**Re: Rio Algom Mining LLC – Ambrosia Lake West Mill
License SUA-1473, Docket No. 40-8905
Request for Amendment to SUA-1473 Regarding the Replacement of Alluvial Monitoring
Well 5-04 ALL**

Proposed Changes for New Mexico Source Materials
License SUA-1473, Condition 34

Figure 3: Proposed Well Design for 5-04 ALL-R

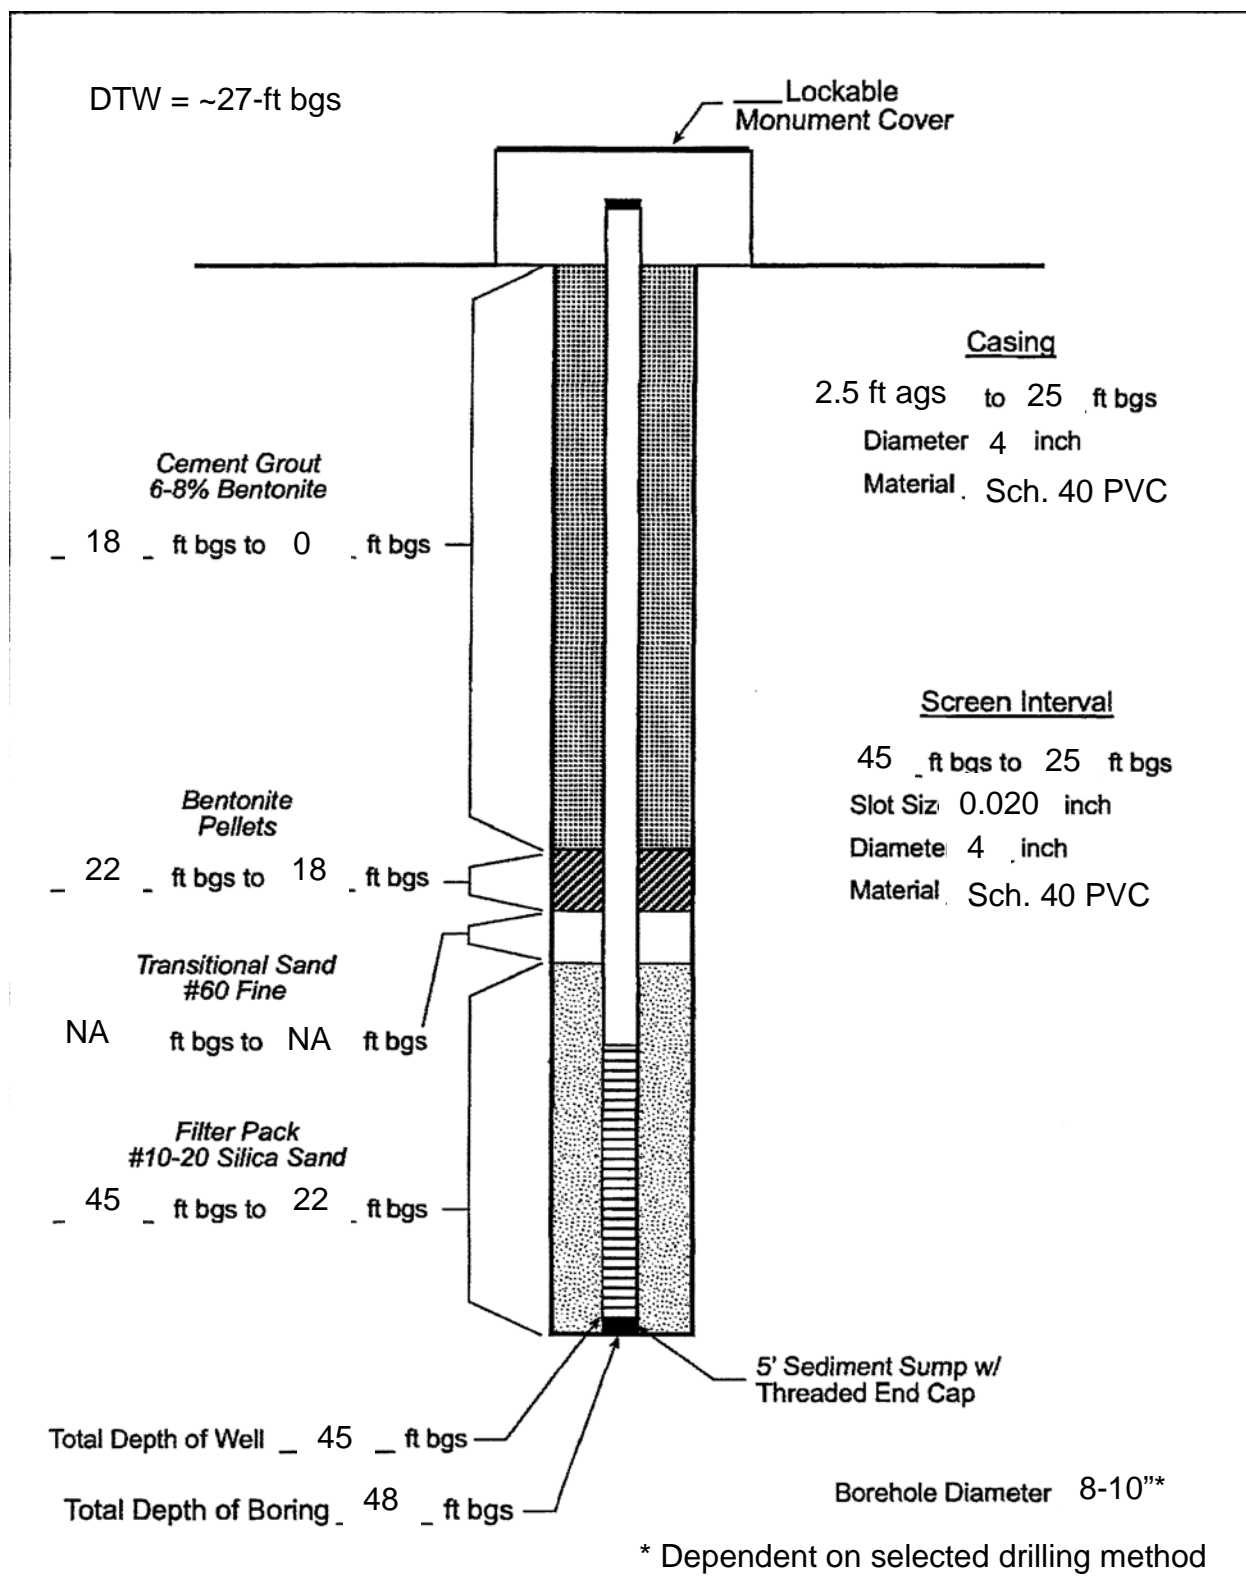
The proposed location for replacement alluvial monitoring well 5-04 ALL-R is at the approximate location shown on **Figure 1**, far enough from 5-04 ALL to avoid potential localized chemical or hydraulic influences associated with abandonment of the original well (for example, pH changes related to a grout plug). 5-04 ALL-R will be screened in the alluvial material. A proposed construction diagram is included as **Figure 3**. Abandonment of well 5-04 ALL and installation of well 5-04 ALL-R will be performed in accordance with permits issued by the New Mexico Office of the State Engineer.

RAML plans to plug, abandon, and replace well 5-04 ALL in time for the replacement well to be in service and sampled for the first half of 2023 sampling event. RAML will provide a construction summary report to NRC documenting the installation and development of well 5-04 ALL-R within 30 days of completing well development and filing of well installation documentation with the New Mexico Office of the State Engineer. Well 5-04 ALL-R will be sampled quarterly for a period of 2 years following installation and development, moving to semi-annual sampling after the 2-year period, per License Condition 34.
